Office Action Summary

10/517,940

DETAILED ACTION

FIG. 22

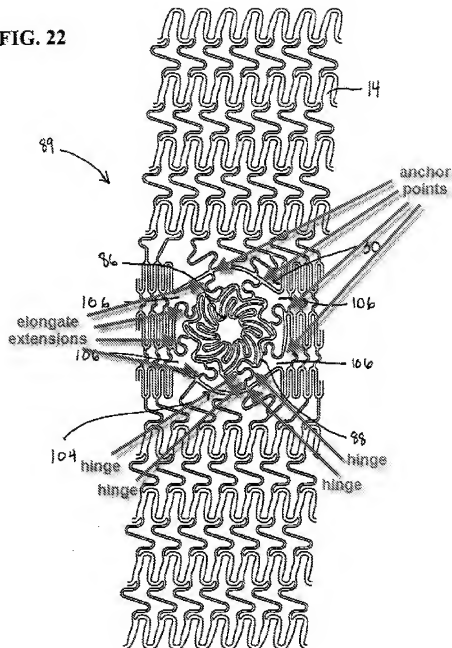
Davidson et al disclose a deformable medical implant comprising a body (14) defining at least two anchor points and being adapted to be deformed so that two anchor points are moved relative to each other, at least two elongate extensions fixed to an anchor point, a bridge (88) coupling at least two of the extensions together, and at least two hinges defined on at least one of the extensions wherein two of said at least two hinges have different preferred bending directions (see annotated figure 22 below; paragraphs 0061-0066);

wherein hinges of one extension are a mirror of hinges on another, coupled extension (i.e., hinges opposite each other with respect to opening (30)); wherein the hinges of one extension have different axial locations, bending directions, and resistances to

bending than corresponding hinges on another, coupled extension; wherein at least one of the hinges has a preferred bending direction in a device plane of the body (e.g., hinges between the anchor points and the bridge) and at least one of the hinges has a preferred bending direction perpendicular to the body (e.g., hinges at the anchor points); wherein the hinges are arranged to cooperate with the bridge to bend the extensions in a direction that includes a component perpendicular to a device plane of the body with the hinges being arranged to bend at least one of the extensions at at least two points in different directions and the hinges being arranged to bend the extensions at least 90 degrees away from the device plane of the body (see figure 21); the extensions being capable of extending axially towards said body prior to moving apart of the anchor points; the bridge being defined at the end of the extensions, being deformable, and being more resistant to bending than the hinges; the hinges being plastically deformable; the at least two hinges comprising at least three hinges on a single extension; the body being cylindrical; the implant being a mesh stent adapted for implanting in a blood vessel wherein the extensions face each other across an aperture in the stent to define a mesh flared section being symmetric about an axis that is at an angle to an axis of the stent, comprising a coupling (104) between different extensions compensating for an the angle of the flared section, being defined on a side of the stent, being generally cylindrical, and wherein the axis of the flared section may be generally perpendicular to an axis of the stent; and the hinges being parts of struts of the implant.
